SUBJECT: KEWAUNEE NUCLEAR POWER PLANT - ISSUANCE OF AMENDMENT
(TAC NO. MA7278)

The amendment revises the Kewaunee Nuclear Power Plant Technical Specifications to increase the allowable number of spent fuel assemblies stored in the spent fuel pools.

Amendment No. 150
License No. DPR-43

SAFETY EVALUATION BY THE OFFICE OF NUCLEAR REACTOR REGULATION
RELATING TO AMENDMENT NO. 150 TO FACILITY OPERATING LICENSE NO. DPR-43
NUCLEAR MANAGEMENT COMPANY, LLC
KEWAUNEE NUCLEAR POWER PLANT
DOCKET NO. 50-305

FIGURE TS 5.4-1

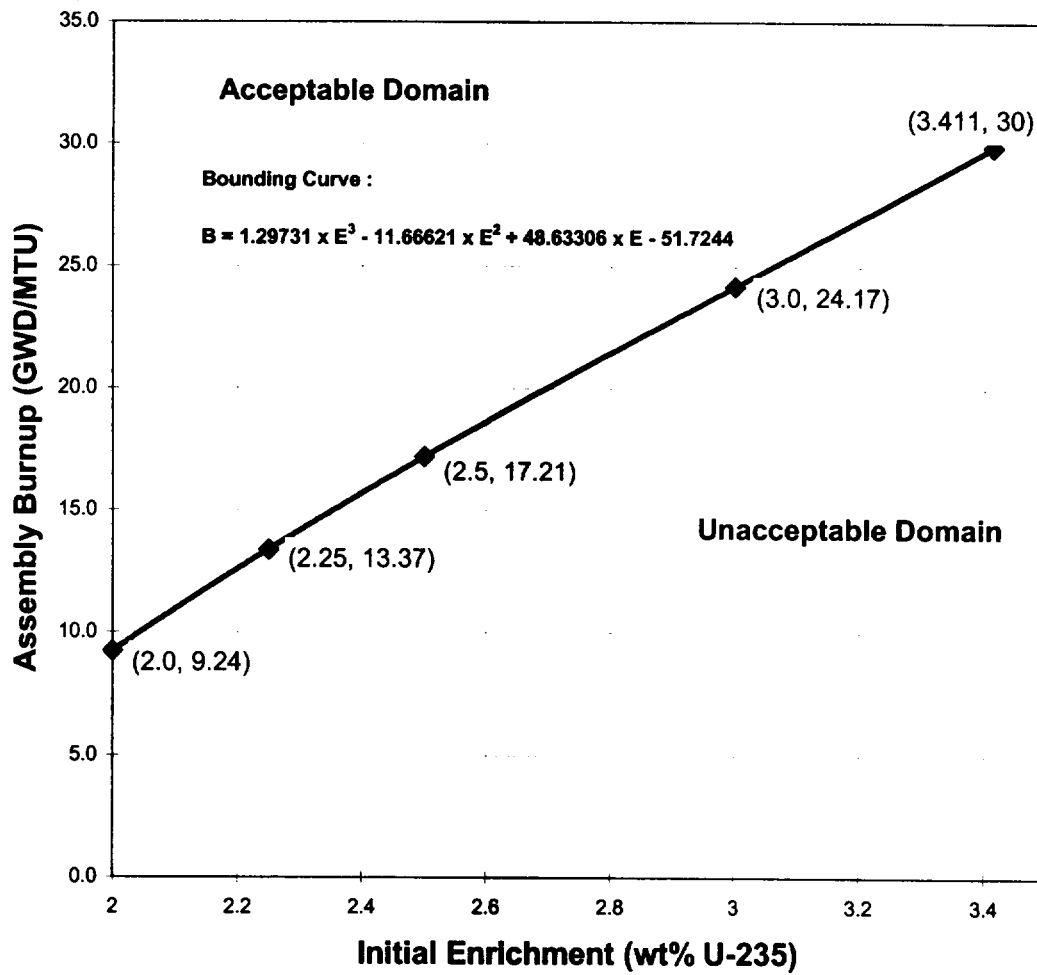
Fuel assemblies stored in the canal racks shall meet the minimum required fuel assembly burnup as a function of nominal initial enrichment as shown in Figure TS 5.4-1. These assemblies shall also have been discharged prior to or during the 1984 refueling outage.

- TS 5.4.b increases the total spent fuel pool storage capacity to 1205 assemblies.
- TS 5.4.c adds the minimum required fuel assembly burnup as a function of nominal initial enrichment for assemblies being stored in the spent fuel transfer canal.
- Figure 5.4-1 is added which specifies the minimum required fuel assembly burnup as a function of nominal initial enrichment for the fuel assemblies being stored in the transfer canal.

concept is based on the reactivity decrease associated with fuel depletion and has been previously found acceptable by the NRC for use in PWR fuel storage analysis. A series of reactivity calculations is performed to generate a set of enrichment versus burnup ordered pairs which yield an equivalent k-eff less than 0.95 (approximately 0.945) for fuel stored in the storage racks. The results are illustrated in TS Figure 5.4.1, which indicate that fuel with an initial maximum nominal enrichment of 3.411 w/o U-235 must achieve a burnup of at least 30 gigawatt days per metric ton uranium (GWD/MTU) to be allowed storage in the proposed spent fuel racks in the transfer canal. Likewise, fuel initially enriched to 2.0 w/o U-235 or less must have accumulated a minimum burnup of 9.24 GWD/MTU.
